MONTLAKE ELEMENTARY SCHOOL DESIGN DEPARTURE RECOMMENDATIONS

Project #3039304-SD

November 22, 2022

Requested Departure #1 : Lot Coverage

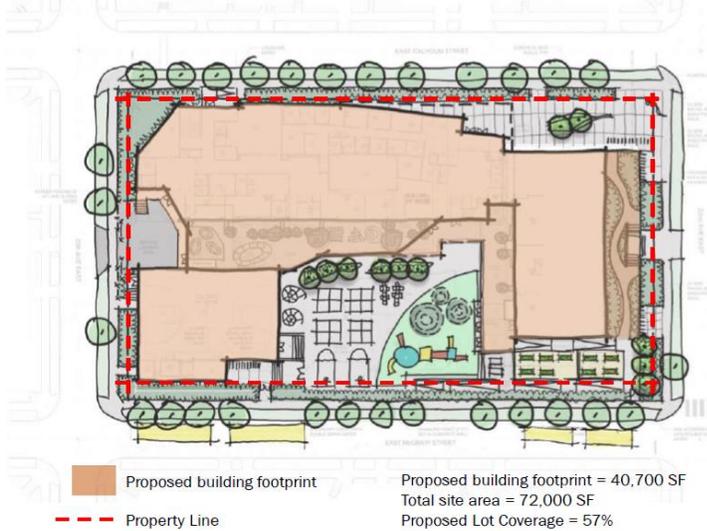
SPS and the Design Team noted in their presentation and in their response to public comments that the limited size of the site necessitates a departure from lot coverage requirements to meet

After consideration of the public comments received and SPS' response, DON recommends:

Requested Departure #2 : Building Height

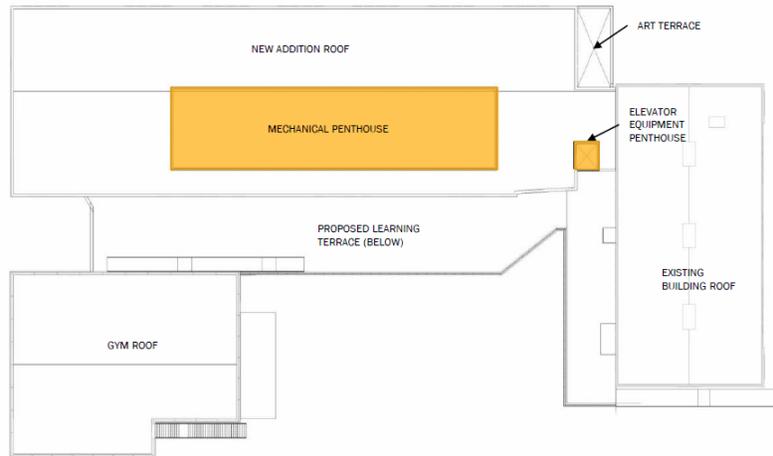
DON received several comments opposing the requested departure. Several individuals commented that it is out of scale and would block sunlight and create shadows in the residential neighborhood. Others commented that it would ruin the views and livability of existing Montlake neighborhood residences. One individual requested SPS provide any shadow studies related to the departure.

SPS and the Design Team noted in their presentation and in their response to public comments that the three-story addition allows for expanded educational programming while also respecting the height and materiality of the existing landmarked building.

After consideration of the public comments received and SPS' response, DON recommends:

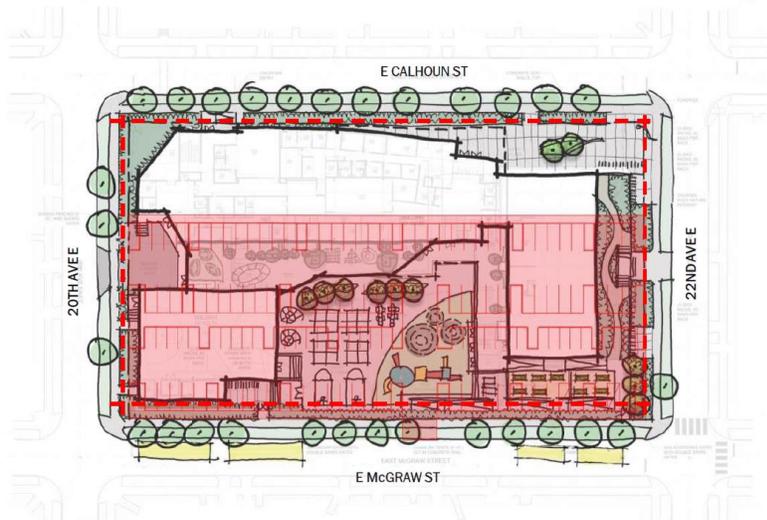
DON received several comments opposing and expressing concerns about the requested departure. These included a comment from an individual that the setbacks are not sufficient, and residents will be confronted with a towering and overpowering wall. One comment expressed that this departure is an attempt to squeeze in a school that is too large for the lot.

SPS and the Design Team noted in their presentation and in their response to public comments that concerns over the building's scale may be lessened by the property line not being at the sidewalk and the existing trees surrounding the site, which will remain or replaced at select locations.

After consideration of the public comments received and SPS' response, DON recommends:

Requested Departure #4 : Vehicular Parking Quantity

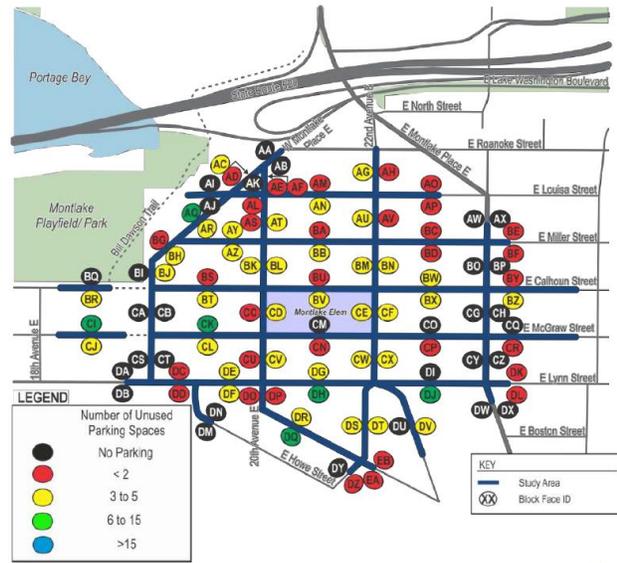
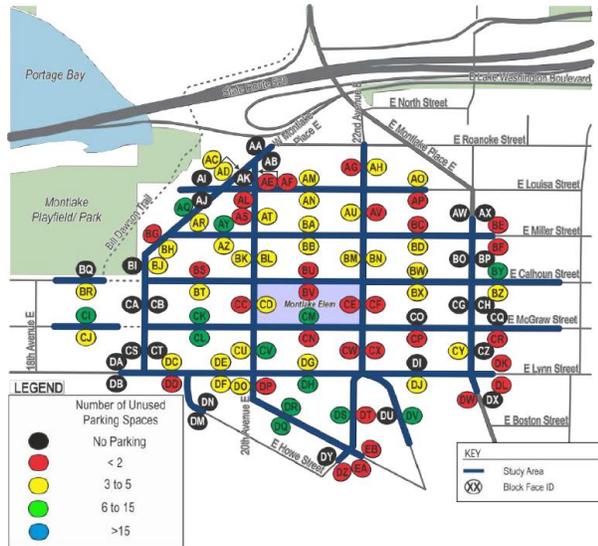
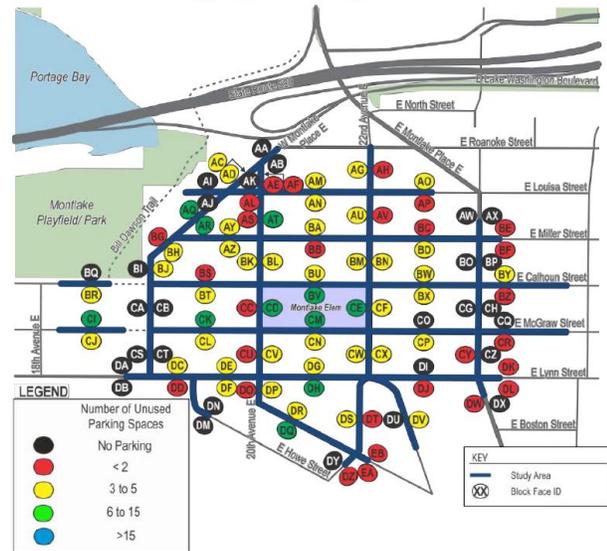
DON received several comments opposing and expressing concerns about the requested departure. These include an individual comment about the lack of disabled parking spaces, compliance with the Americans with Disabilities Act (ADA), and lack of a bus loading area. One comment expressed that parking for additional staff and students are non-existent and will not be adequate. One individual commented that this departure is an attempt to squeeze in a school that is too large for the lot.

SPS and the Design Team noted in their s presentation and their response to public comments that the current school bus loading and unloading occur on-street in the existing bus loading zone area and there is no striped vehicular parking on-site. The proposed design maintains the existing conditions related to bus loading and striped vehicular parking.

- 1) **Transportation Management Plan (TMP):** Prior to the school reopening, SPS and the principal of Montlake Elementary should establish a TMP to educate families about access load/unload procedures for the site. They should require the school to distribute information to families about onsite vehicular access as well as travel routes for approaching and leaving the school. Staff and parents should also be instructed to not block or partially block any residential driveways with parked or stopped vehicles.

- 3) **Neighborhood Communication Plan for School Events:** SPS and Montlake Elementary's administration should develop a neighborhood communication plan to inform nearby neighbors of large events each year. The plan should be updated annually (or as events are scheduled) and provide information about the dates, times, and magnitude of large-attendance events. The communication would be intended to allow neighbors to plan for occasional increases in on-street parking demand that would occur with large events.

Requested Departure #7 : Bicycle Parking (Long Term) Quantity

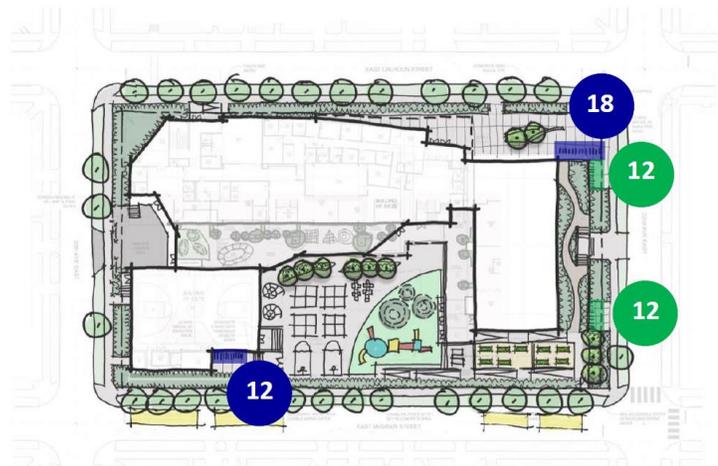
DON received several comments that expressed concerns regarding the requested departure for long term bicycle parking quantity. These include an individual comment about providing bicycle parking that meets the minimum requirements of the SMC, especially for covered parking. Other comments also expressed support for access to safe, secure, innovative, and long-term bicycle parking solutions.

SPS and the Design Team noted in their presentation and their response to public comments that the proposal provides 30 long term bicycle spaces. The current site does not provide any facilities that meet the SMC standards for long-term bike parking. The proposed quantity brings the site closer to compliance with the SMC.

Requested Departure #9 : Electric Changing-Image Sign

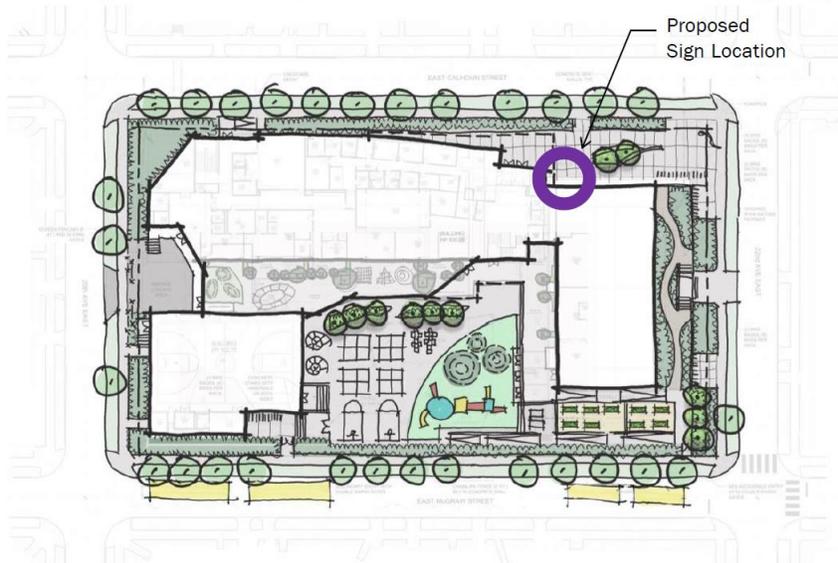
SPS and the Design Team noted in the departure request and their response letter that the sign would not include video, flashing, scrolling, or moving images and would only operate during specific times (7am to 9 pm).

- 1) **The electric reader board may only be turned on between 7am to 9pm.**
- 2) **No video, flashing, scrolling, or moving images; however, messages can change to show content.**
- 3) **Sign illumination should be limited to one color with a dark background.**
